### **REMARKS**

Appl. No. 09/602,690  
Amdt. dated May 17, 2004  
Annotated Sheet Showing Changes

FIGURE 3A

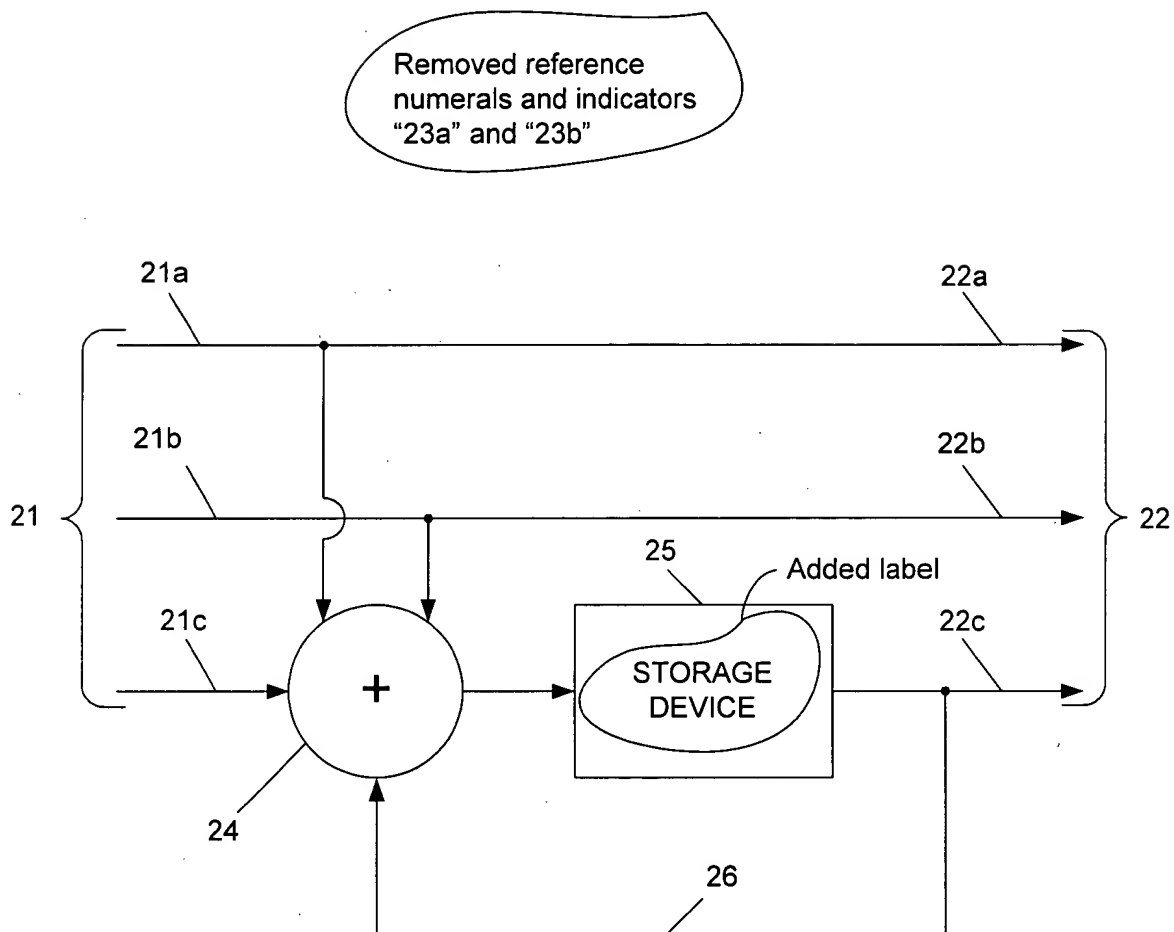
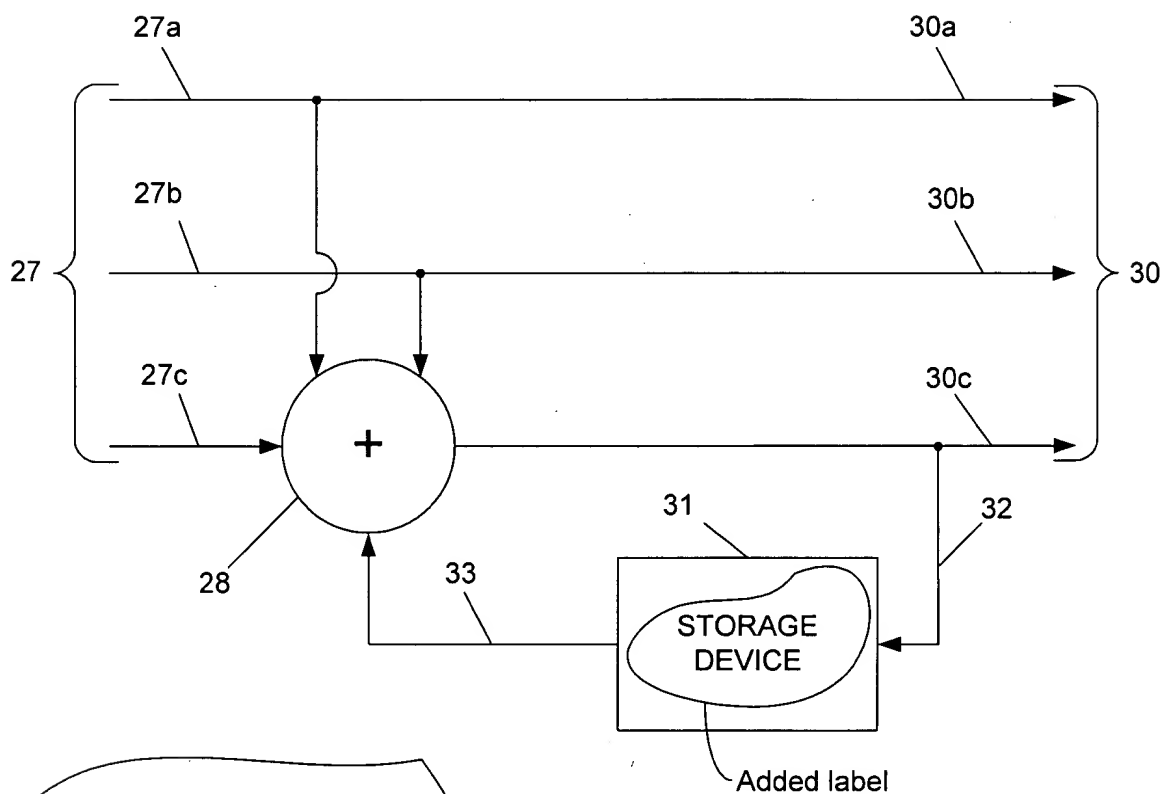
Removed reference  
numerals and indicators  
"29a" and "29b"

Removed arrows from  
reference indicators 27a,  
27b, 27c, 28, 30a, 30b, 30c,  
32, 33

FIGURE 5

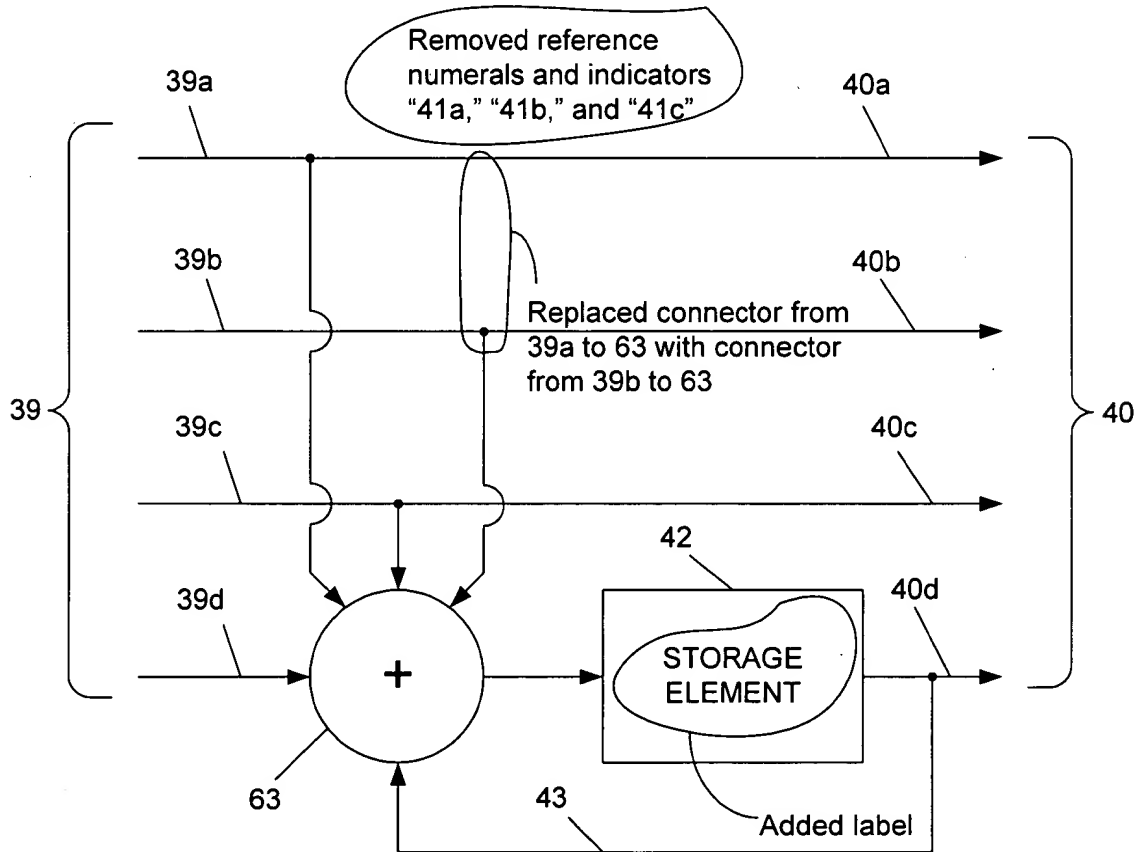
In Figure 5, the original drawing contained an obvious drafting error showing a connector from 39a to 63. In the amended Figure 5, the error has been corrected by replacing the connector with a new connector from 39b to 63, as described in the spec on page 8, lines 30-31.

Removed arrows from  
reference indicators 48, 49

FIGURE 6

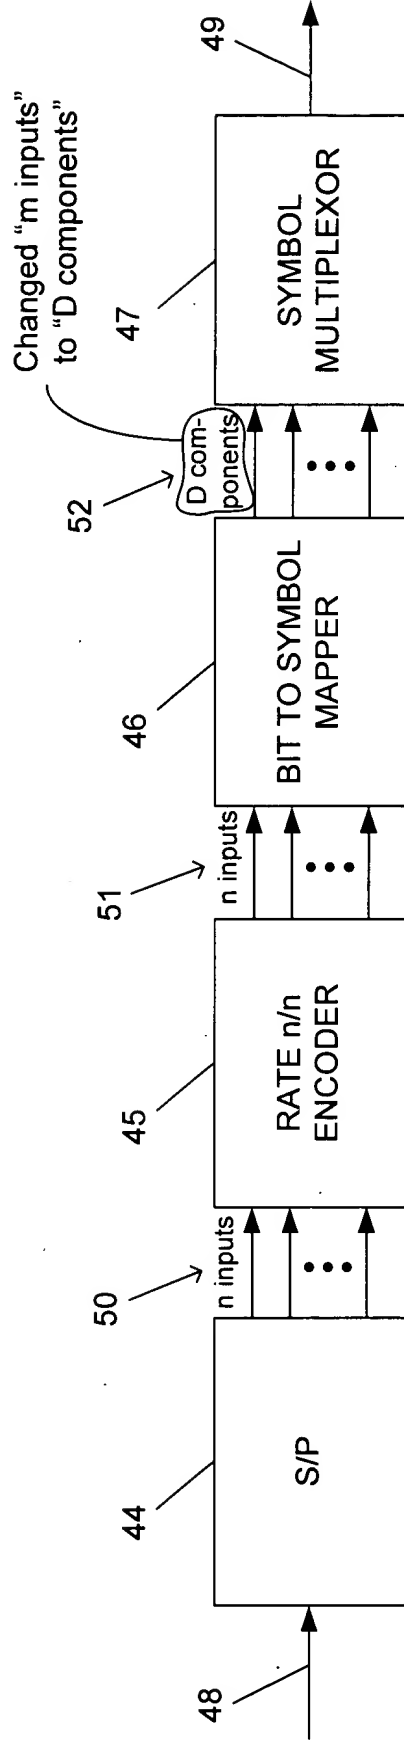
In Figure 6, the original drawing contained an obvious drafting error, mislabeling inputs 52 as "m inputs." In the amended Figure 6, the error has been corrected by replacing the label with a new label "D components," as described in the spec on page 9, lines 18-24.

FIGURE 9B

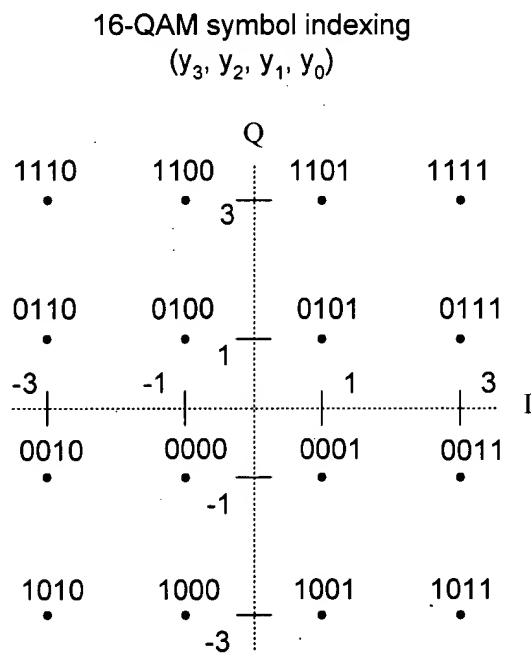
Centered  
Figure 9B

FIGURE 10

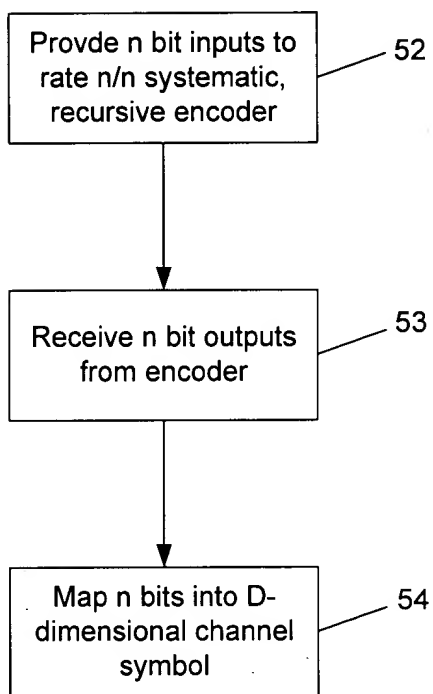
Centered  
Figure 10

FIGURE 11A

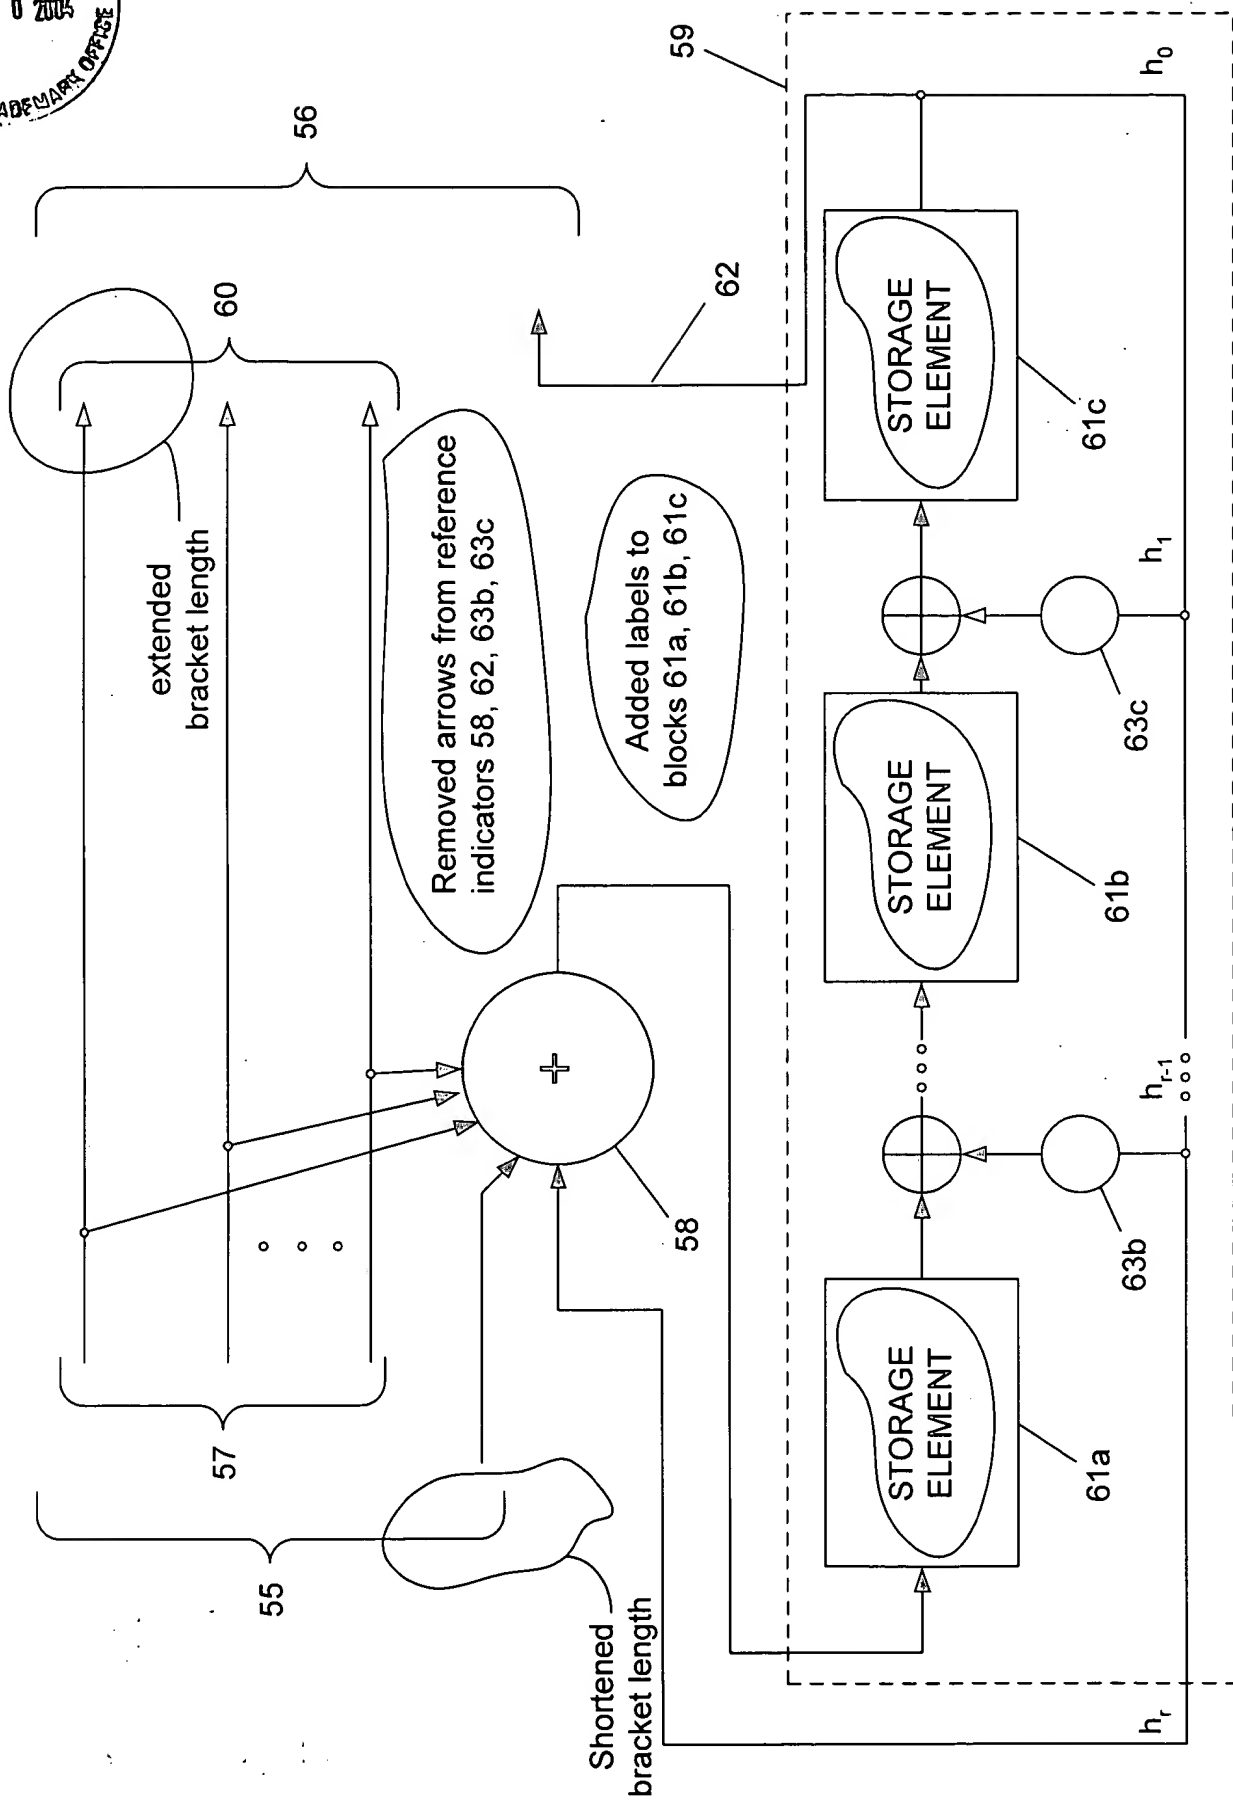
In Figure 11A, the original drawing contained obvious drafting errors showing misplaced brackets 55 and 60. Bracket 55 is too long, because it should not include feedback input 62 to adder 58. Bracket 60 is too short, because it does not include the top-most input of inputs 57. In

the amended Figure 11A, these errors have been corrected by reducing the length of bracket 55 so that it does not include feedback input 62, and by increasing the length of bracket 60 so that it also includes the top-most input of inputs 57. These changes are in accordance with the spec as described on page 6, lines 4-15.

FIGURE 11B

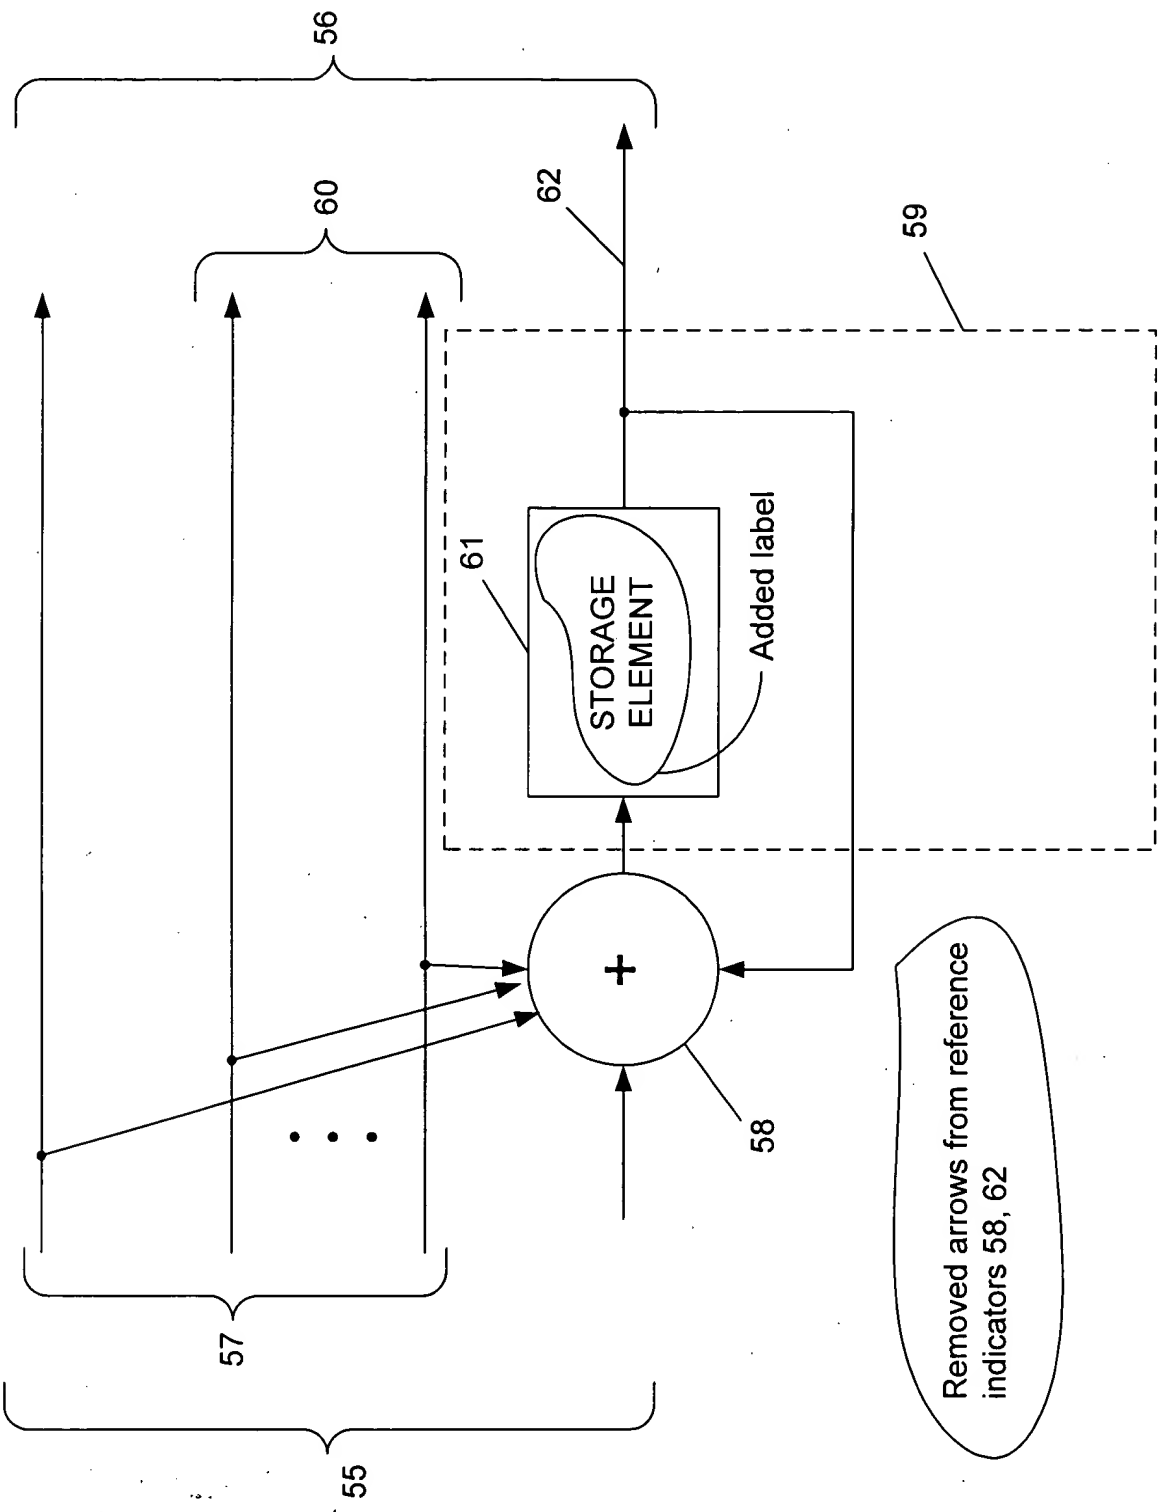
Removed arrows from reference indicators 58, 62

Deleted reference numeral and indicator "200"

FIGURE 16

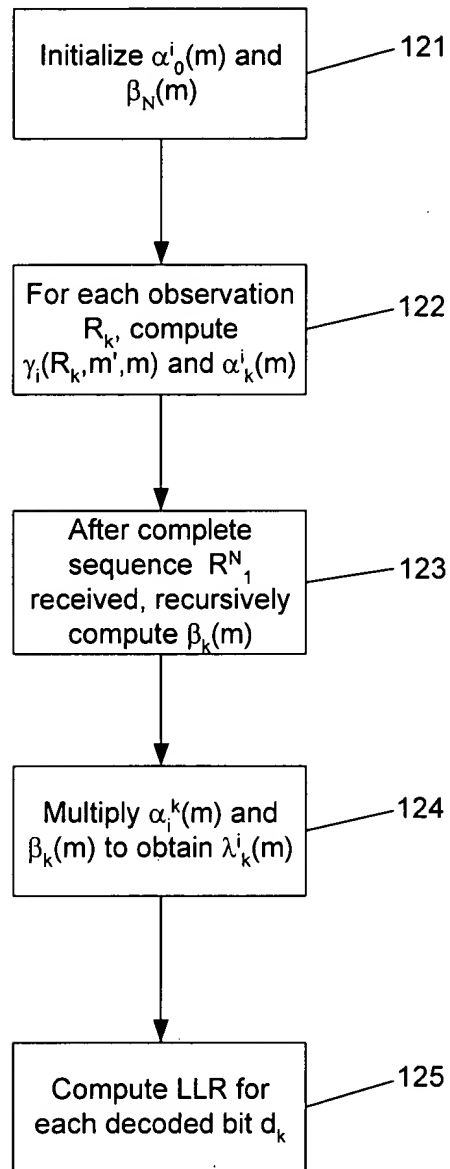
Centered  
Figure 16
